# IRC - Building

## 2016 GROUP B PUBLIC COMMENT AGENDA

OCTOBER 19 - OCTOBER 25, 2016  
KANSAS CITY CONVENTION CENTER  
KANSAS CITY, MO

**FIGURE R507.5  
TYPICAL DECK JOIST SPANS**

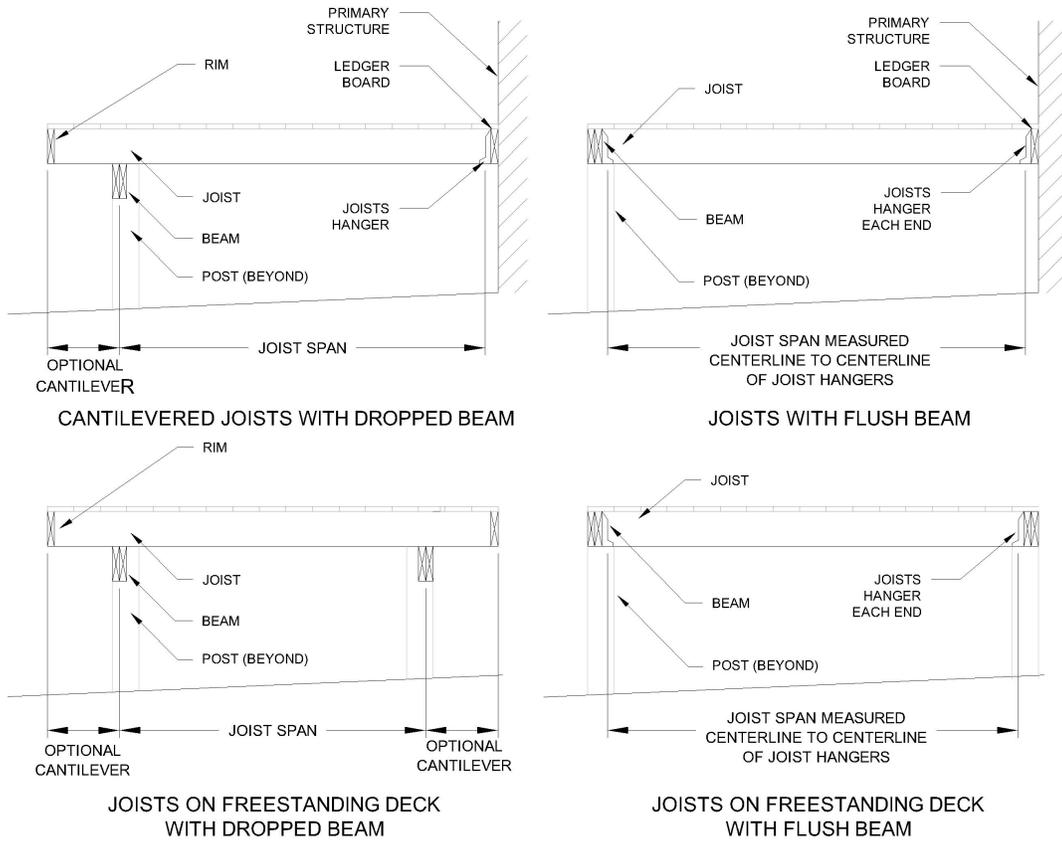
Maximum allowable spans for wood deck joists, as shown in Figure R507.5, shall be in accordance with Table R507.5. Deck joists shall be permitted to cantilever not greater than one-fourth of the actual, adjacent joist span.

**FIGURE R507.1.1**  
**Freestanding decks.**

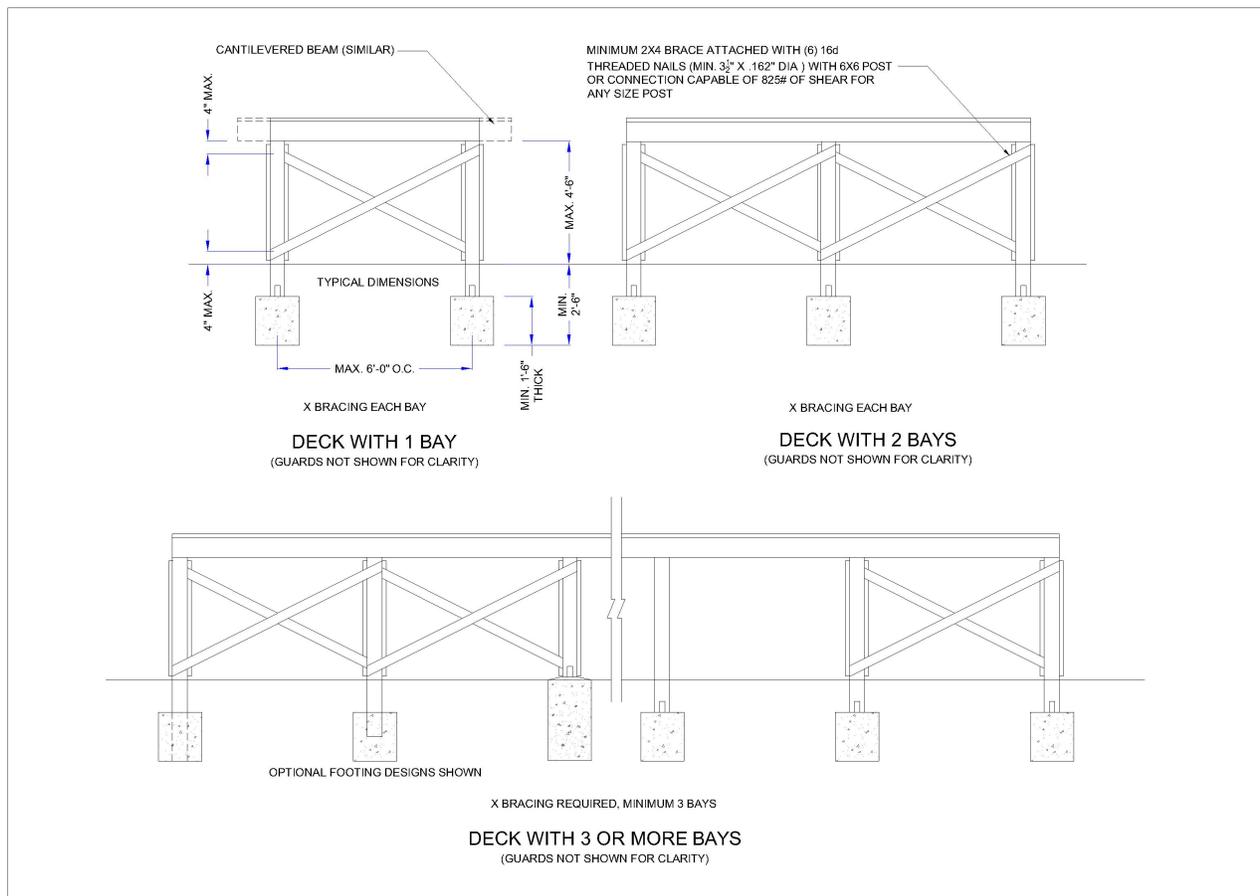
**R507.1.1 Freestanding decks.** Freestanding decks shall be self-supporting and constructed limited in height to provide a complete load path 4'-6" measured from the underside of the beam to transfer both vertical and lateral loads to their foundation the finished grade where constructed in accordance with Figure R507.1.1. ~~The lateral resistance Freestanding decks greater than 4'-6" above grade shall be permitted to be designed in accordance with accepted engineering practice R301.~~

**R507.1.1.1 Lateral bracing.** Freestanding decks shall be constructed to provide a complete load path to transfer both vertical and lateral loads to their foundation. Lateral bracing shall be provided between adjacent posts in accordance with Figure R507.1.1.

**FIGURE AV104.3**  
**Components of masonry fireplace with chimney reconstruction from top of smoke chamber up.**

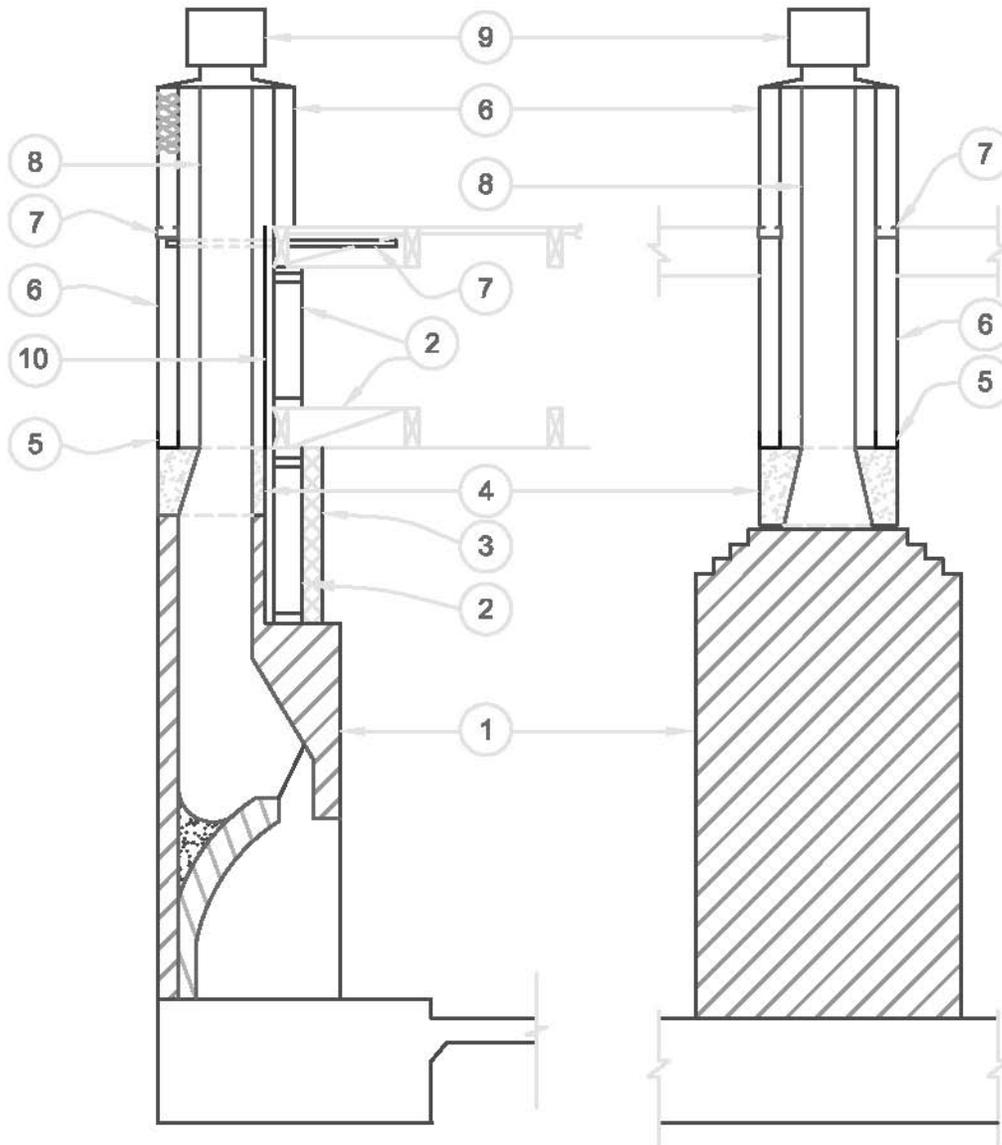
**AV104.3 Chimney partial removal.** The chimney shall be removed down to the top of the smoke chamber-to-chimney transition, as shown in Figure AV104.3.
